PROJECT: DCSD 2021 CIP - Parker Package **CONTRACTOR:** Mark Young Construction
DATE: July 23, 2021 **CHANGE ORDER #:** 14

Subject: **Change Order Request #21 – CCD #7 Structural Steel Revisions**

CONSTRUCTION CHANGE DIRECTIVE

PROJECT: Pine Lane Elementary School - North
Douglas County School District 2021 CIP Projects

Reflected Ceiling Plan

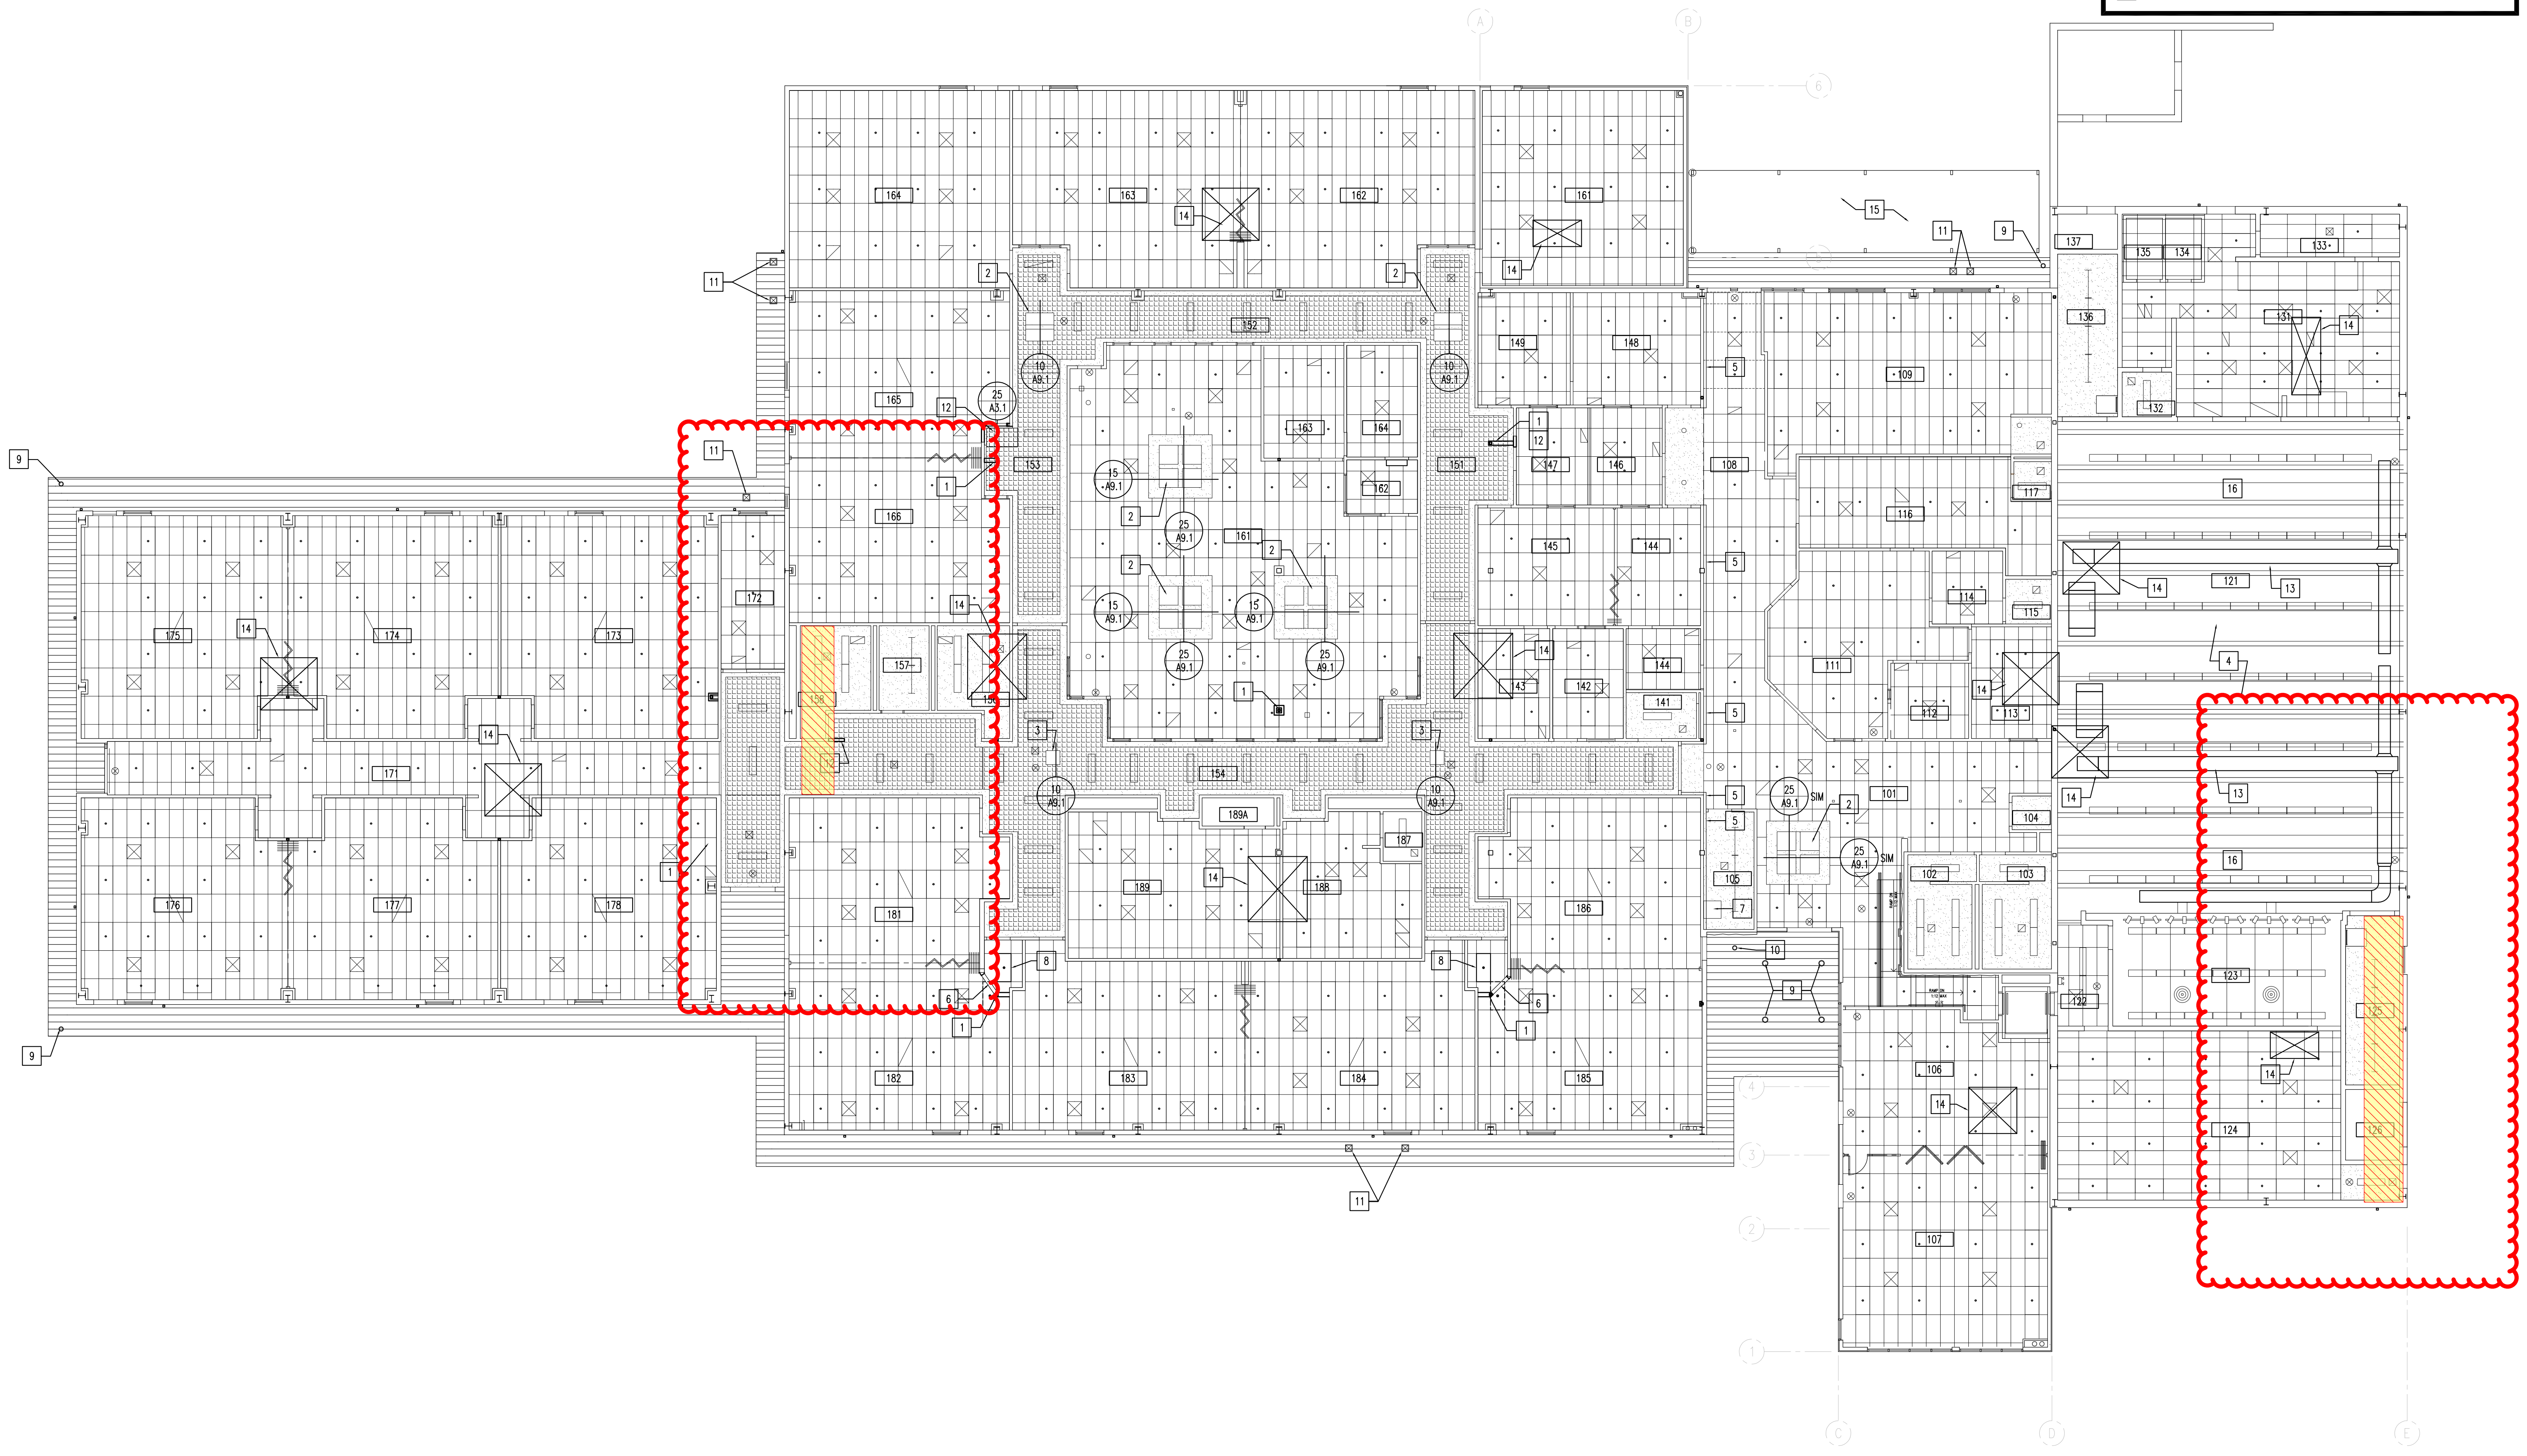
Other areas affected by Structural steel revisions

ROOF FRAMING PLAN

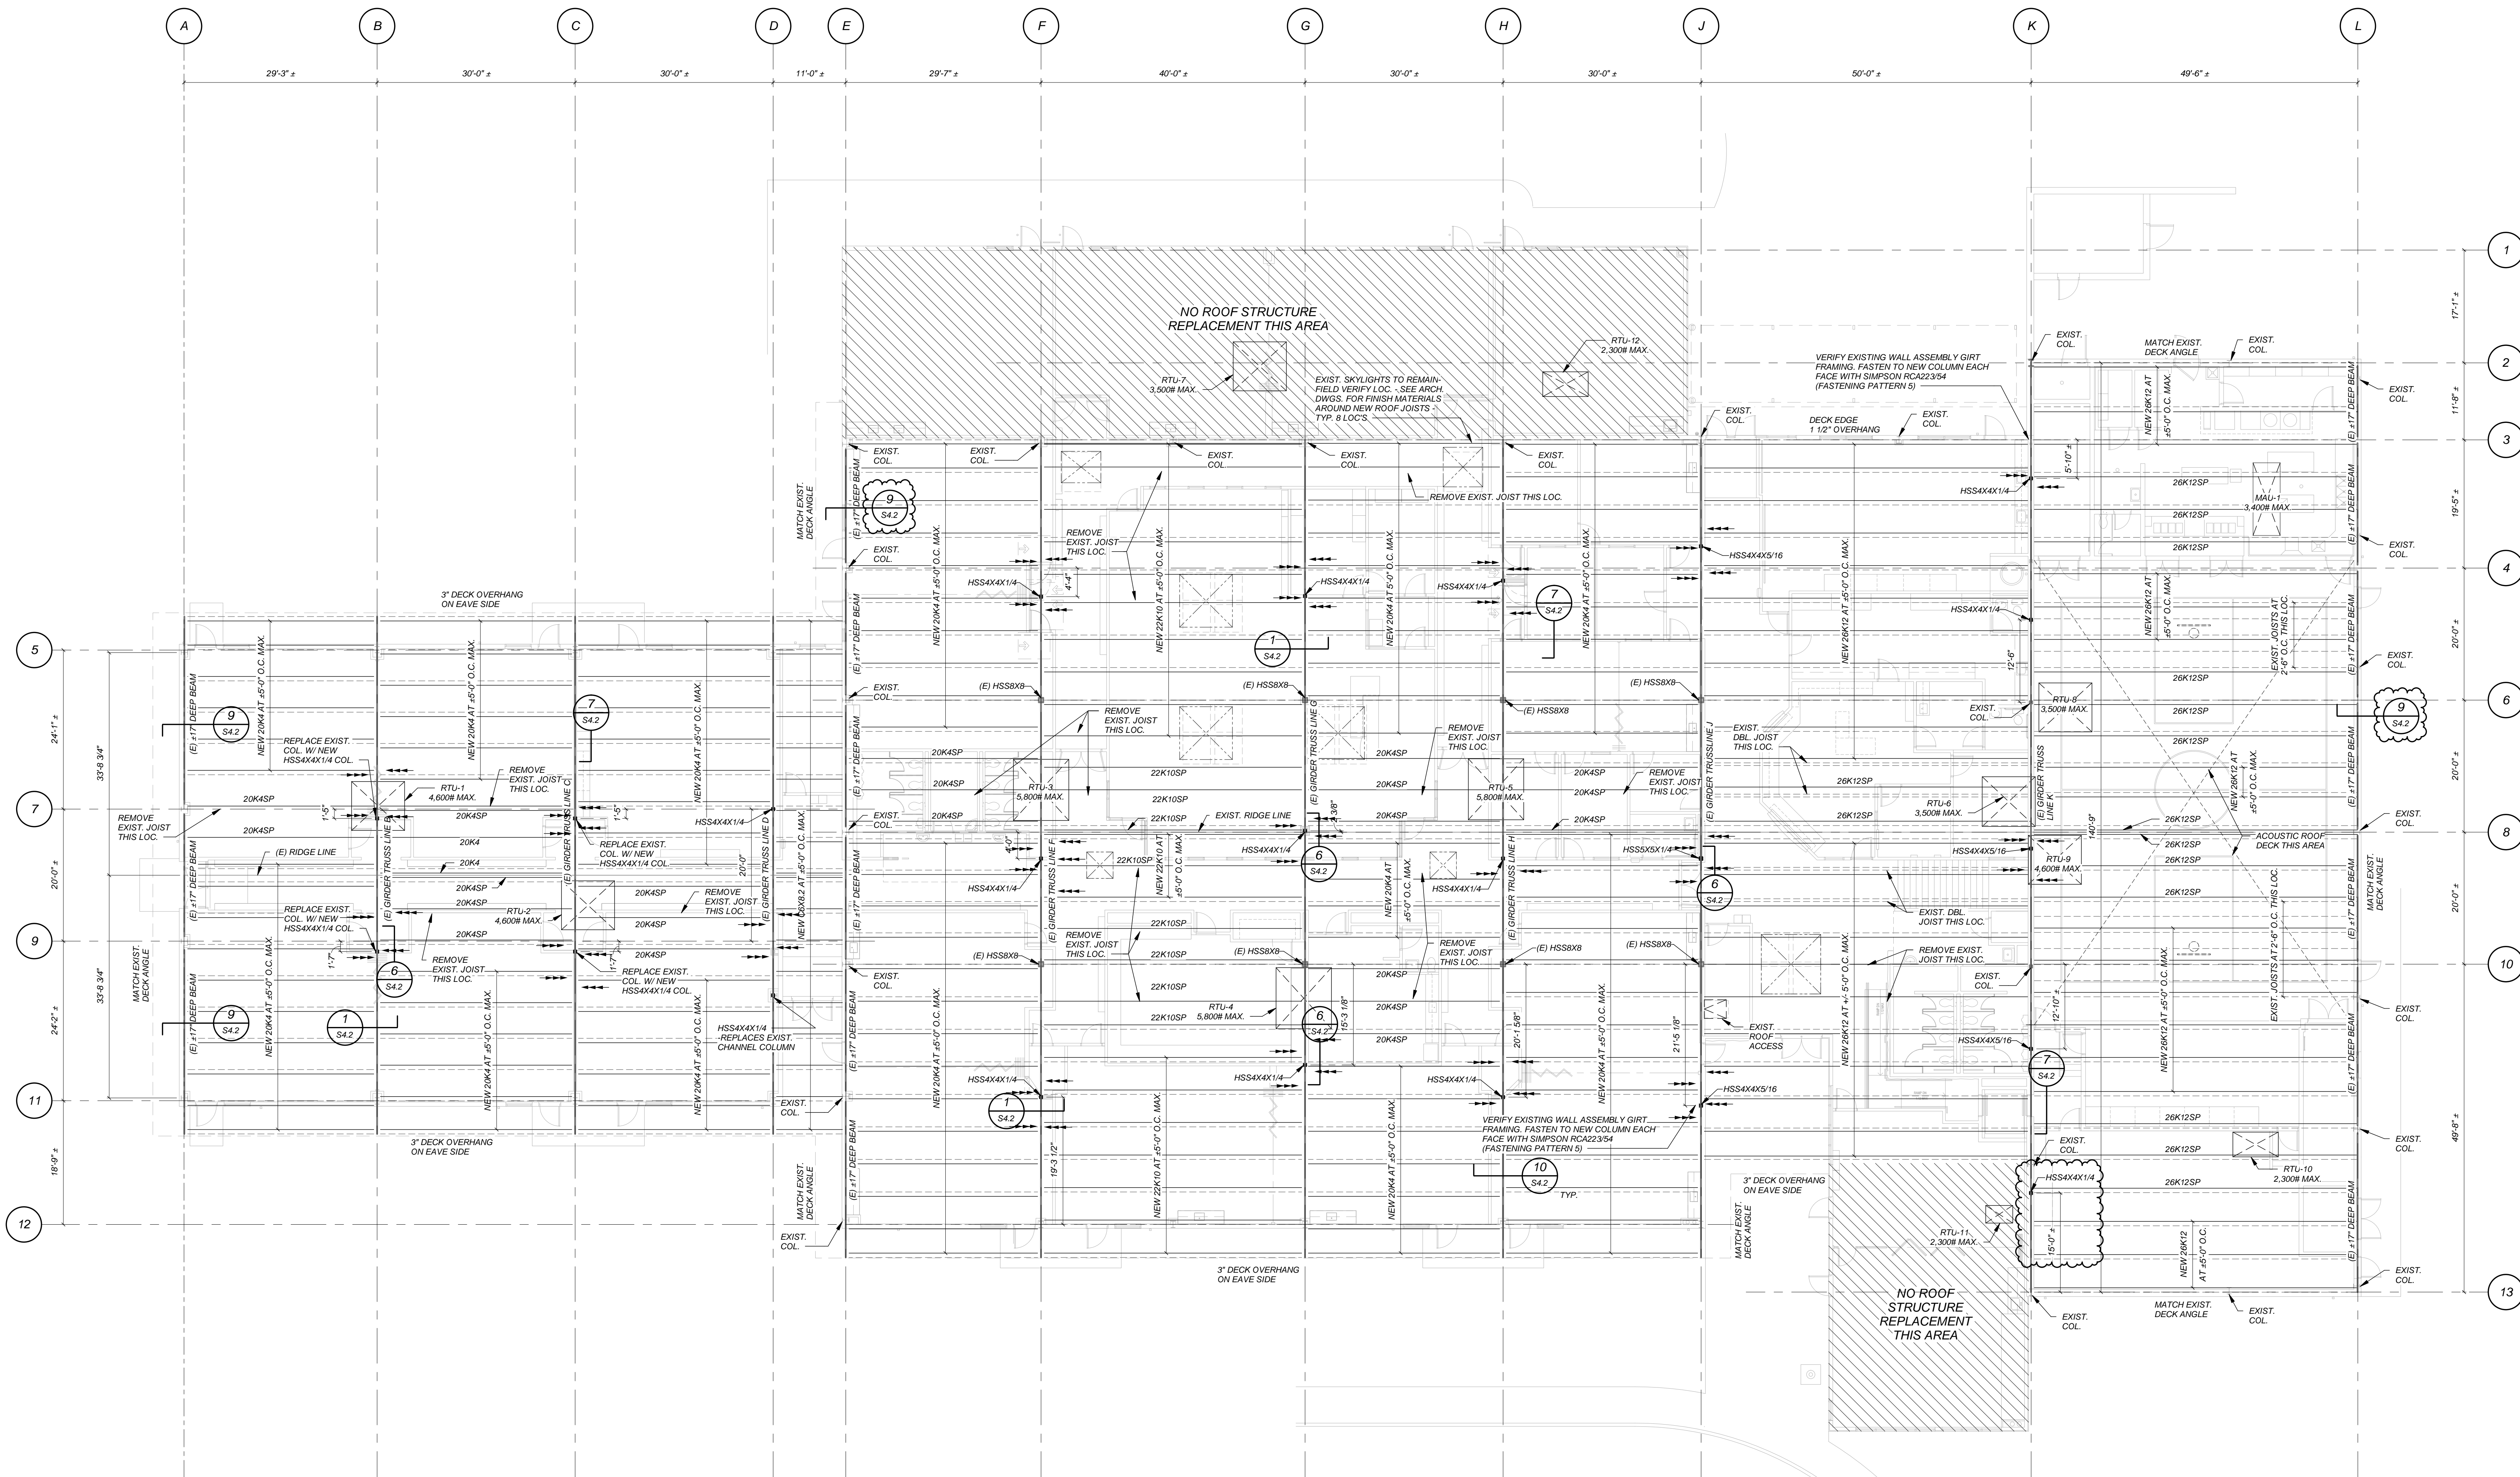
1. Work indicated on the drawings including new column. Replace Sheet S4.1, S4.2 and S4.3 with the attached sheets marked 'CCD 7 rev 1 6 July 2021'.
